Groundwater Application Review Summary Form

Application # G- 19000

PUBLIC INTEREST REVIEW FOR GROUNDWATER APPLICATIONS

TO: Water Rights Section Date 11/15/2022
 FROM: Groundwater Section Jen Woody
 SUBJECT: Application G- 19000 Supersedes review of 8/31/2020, 11/15/2021
 Date of Review(s)

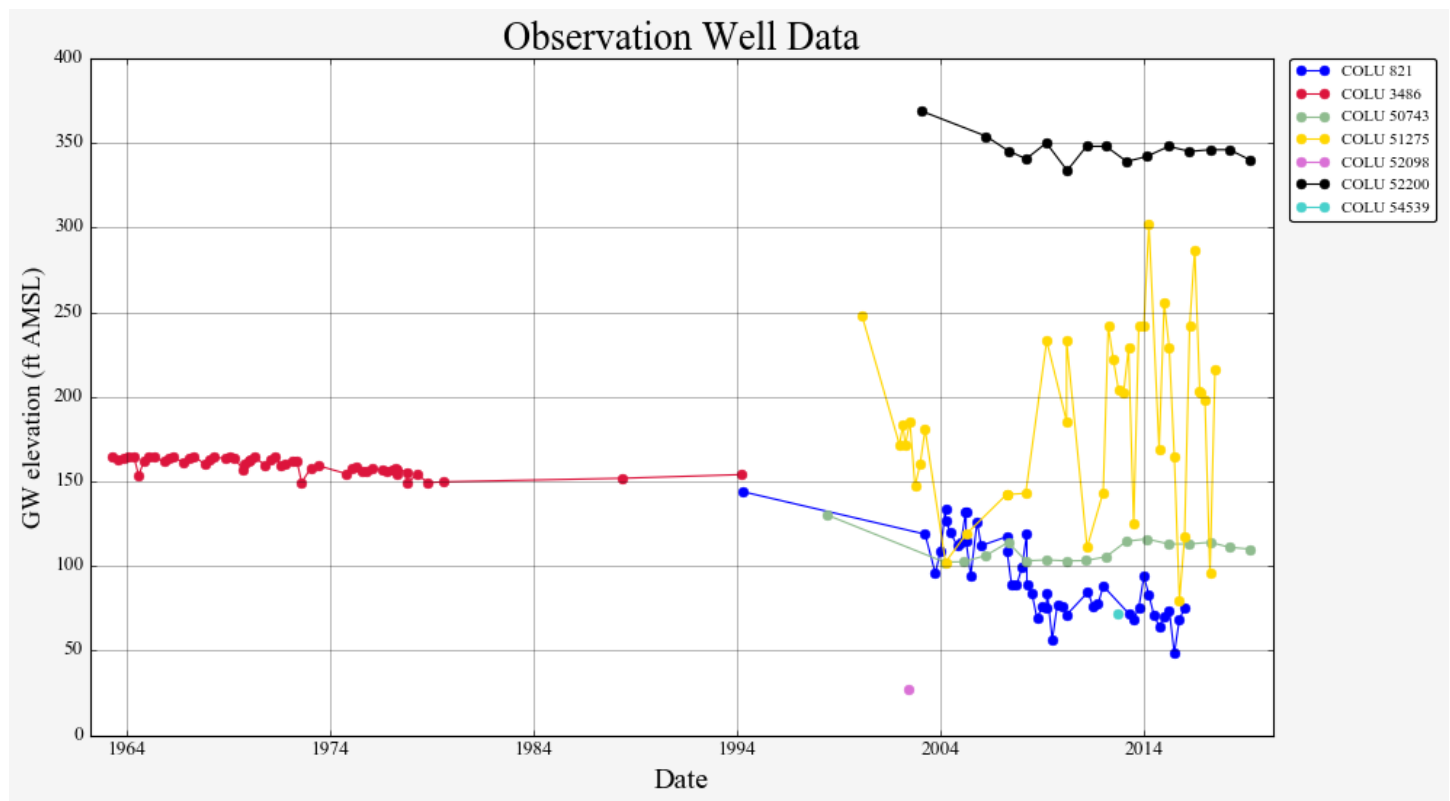
The nearest well known to access basalt is COLU 52098, an exempt well located approximately 1.25 miles west of the subject wells. The potential for interference with this well from the proposed use was modeled using the Theis, (1935) equation for drawdown in a confined aquifer and parameters from nearby pumping tests (see Theis Drawdown Analysis below). Results indicate that the proposed use would cause well-to-well interference with COLU 52098 likely limited to less than 15 feet over 6 months of continuous pumping at the maximum proposed rate (0.8 cfs) from Well #3. Therefore, the conditions proposed above should avoid injury to other groundwater users and to the groundwater resource.
